### STAFF RECOMMENDATION 400 Broadway October 19, 2016

**Application:** New construction—alteration to previously approved addition  
**District:** Broadway Historic Preservation Zoning Overlay  
**Council District:** 19  
**Map and Parcel Number:** 09306308200  
**Applicant:** Joshua Hughes, Tuck Hinton  
**Project Lead:** Melissa Baldock, melissa.baldock@nashville.gov

**Description of Project:** Application is to alter the design of previously-approved rooftop and rear additions.

Figure 1. 400 Broadway.

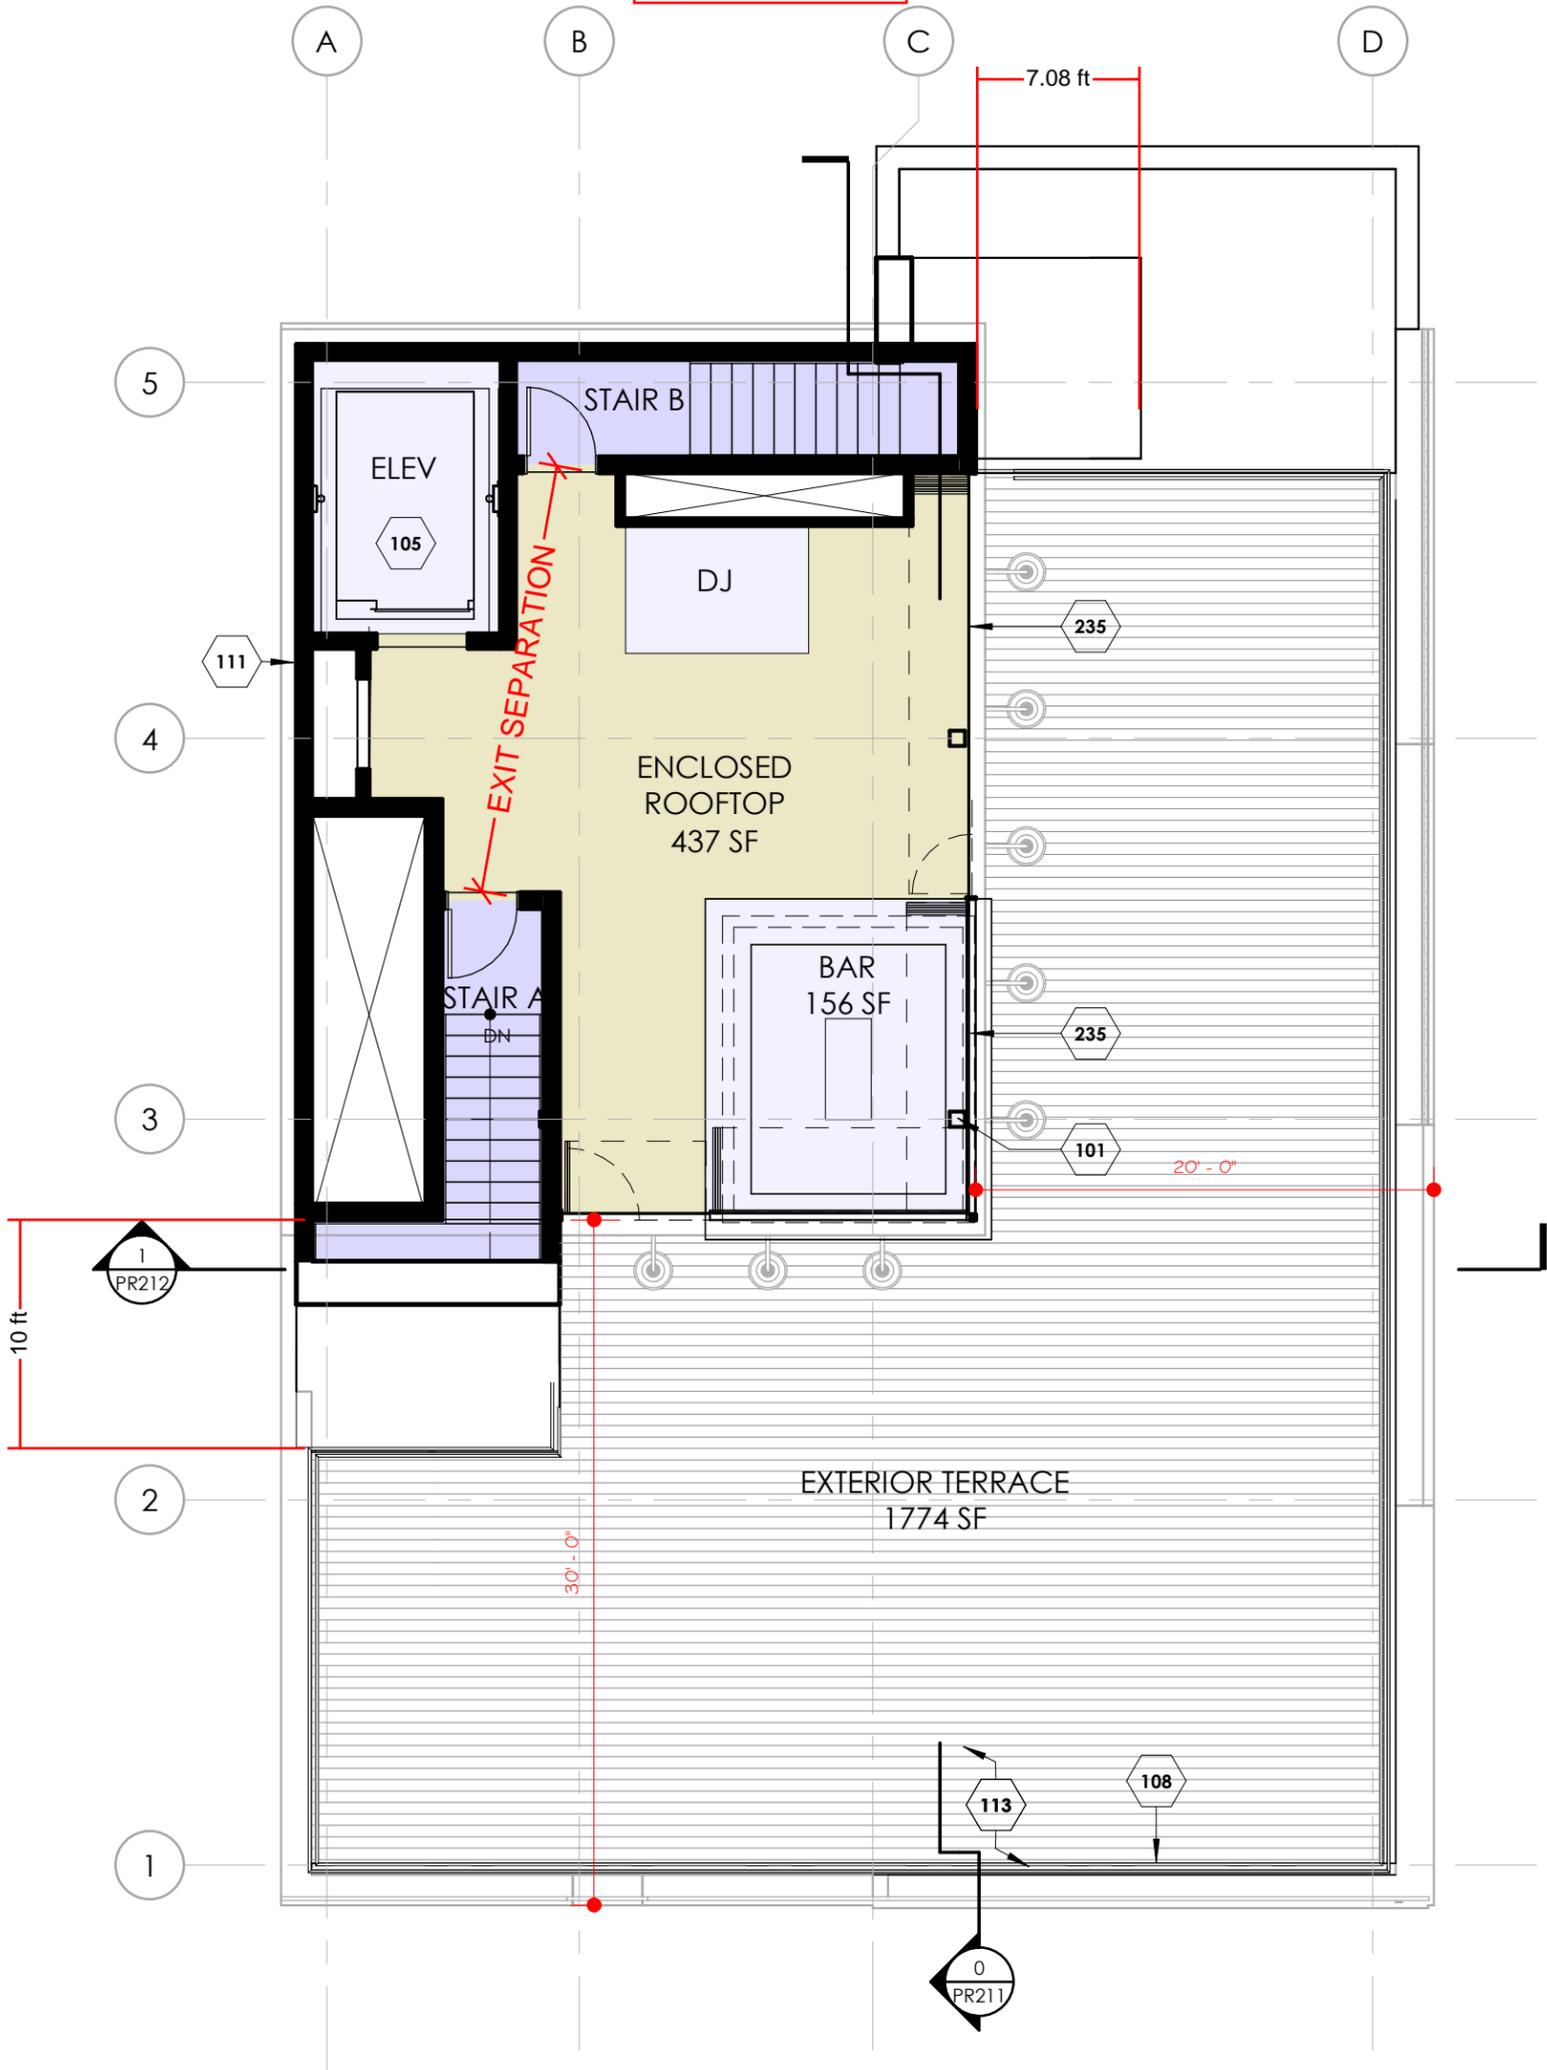
**Background:** 400 Broadway is a c. 1870 brick commercial structure that contributes to the Broadway Historic Preservation Zoning Overlay (Figure 1). The western-most portion of the building was altered in the early to mid-twentieth century with new window openings and steel windows. The building was altered again in 1990. The storefronts date to that restoration. In July 2016, the Historic Zoning Commission approved alterations to the building’s storefronts, new lighting, and a rooftop and rear addition. This application seeks to change the size of the previously-approved rooftop and rear additions.

LEVEL 4 ROOF PLAN

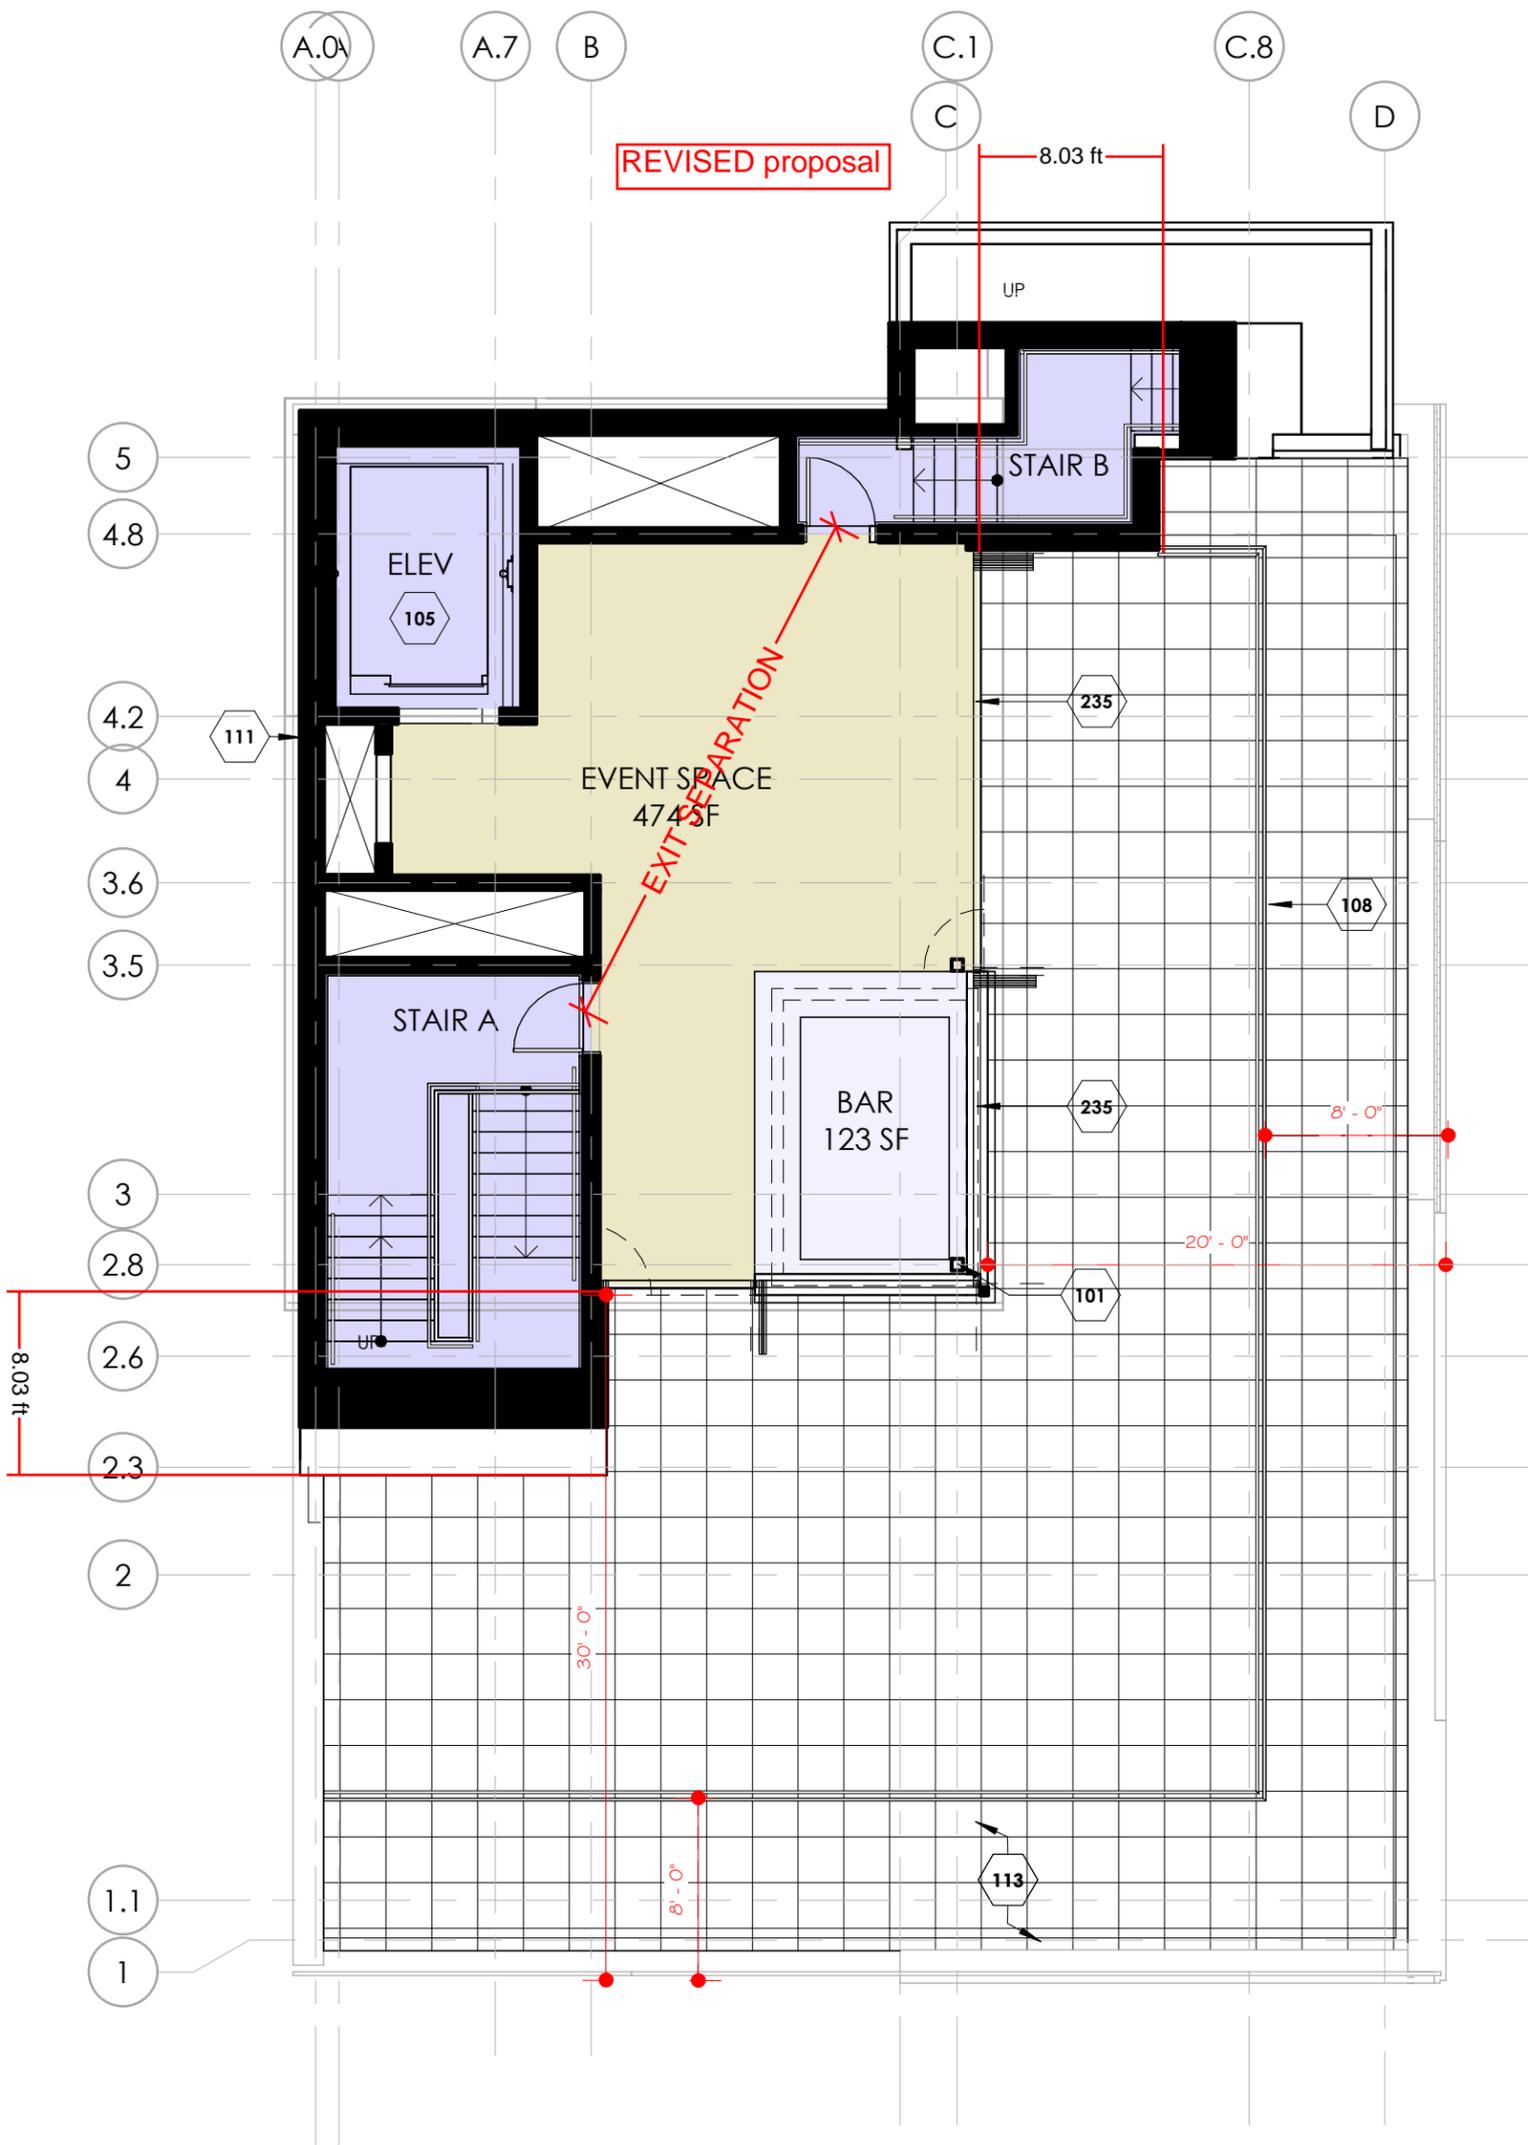
Rooftop Addition: The height and scale of the main portion of the rooftop addition has not changed since the Commission voted to approve the project, with conditions, in July. It is the height, scale, and step backs of the stairwell bulkheads that are within the required stepback area that have been altered in the new proposal.

The stair bulkhead on the front façade of the rooftop addition was approved to extend ten feet (10') into the thirty foot (30') step back; of this ten feet (10'), approximately eight feet (8') was above the line of the lower parapet on Fourth Avenue North. The proposed revision will extend just eight feet (8') into the Broadway stepback area, but all of it will be above the height of the parapet on Fourth Avenue North. The revised bulkhead has a taller height than what was previously approved. The bulkhead was approved to be approximately five feet (5') above the parapet at the front, and the revised plans show it to be approximately six feet (6') above the parapet at the front. The revised bulkhead is still slanted so that the tallest portion of the bulkhead is further back. Staff finds that the revised height of the bulkhead to be in keeping with previous Commission decisions to allow intrusions into the required rooftop's addition stepback area. At six feet (6'), the bulkhead will likely be at most minimally visible, and staff therefore finds that its encroachment to the required stepback is appropriate.

The revised proposal also includes changes to the stair bulkhead on the Fourth Avenue North façade. In July, the Commission approved a stairwell bulkhead that encroached approximately seven feet (7') into the stepback area and that had a height of about three feet (3') above the parapet. However, the portion of the stair bulkhead that intruded upon the stepback area was lower in height than the parapet. The revised plans show an encroachment of eight feet (8') and a height of seven feet (7') above the parapet on Fourth Avenue North. Staff finds that the revised height of the bulkhead to be in keeping with previous Commission decisions to allow intrusions into the required rooftop addition stepback area. The bulkhead is designed to so that its tallest portion is furthest from the parapet wall, and will likely be at most minimally visible. Staff therefore finds that its encroachment to the required stepback is appropriate.

The location of the railing has changed since the previous application in July. The railing will be stepbacked eight feet (8') from the Broadway and the Fourth Avenue North facades, which meets the design guidelines.

Staff finds that the alterations to the previously approved rooftop stair bulkheads and rooftop railing meet Section III.H. of the Broadway Historic Preservation Zoning Overlay design guidelines.

REAR ELEVATION

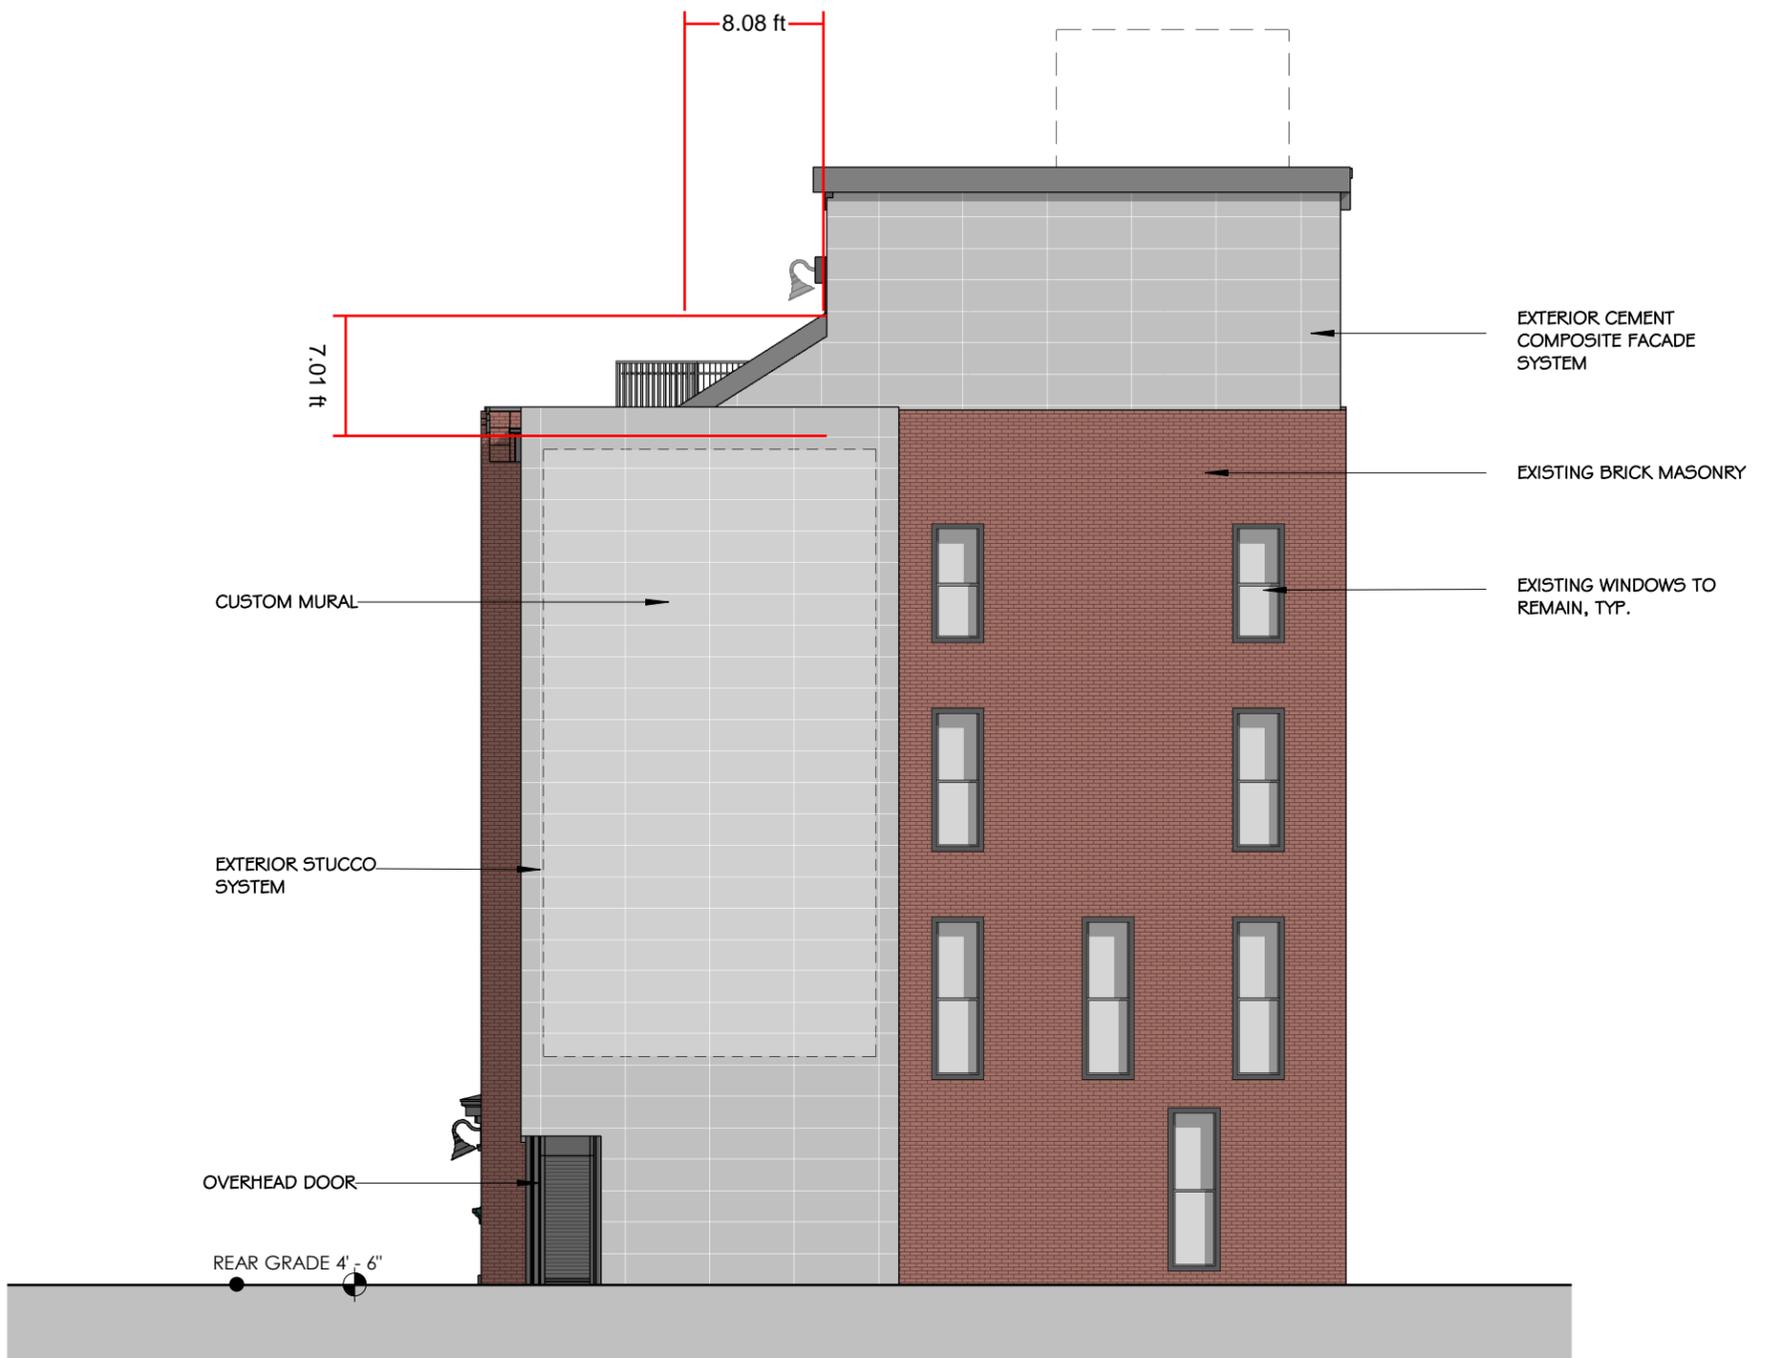
Rear Addition: The applicant is proposing a stairwell addition at the rear. The revised drawings show that the height of the rear addition has decreased from approximately fifty two feet (52') to fifty-one feet (51'). The addition is also inset further from the edge of the historic building. In July, MHZC approved the addition to sit just a few inches from the back corner of the building, and the new proposal shows the addition as being located approximately two feet (2') in from the corner of the historic building. Staff finds these changes to be appropriate. Staff is working with the applicant on approval of the material for this rear addition. With the condition that staff approve the final material choice, staff finds that the proposed rear addition meets Section II.N. and III.H. of the design guidelines.

**Recommendation Summary:** Staff recommends approval of the project with the condition that staff approve the final material choice for the rear addition. With this condition, staff finds that the proposed additions meet Section III. of the *Broadway Historic Preservation Zoning Overlay: Handbook and Design Guidelines*.
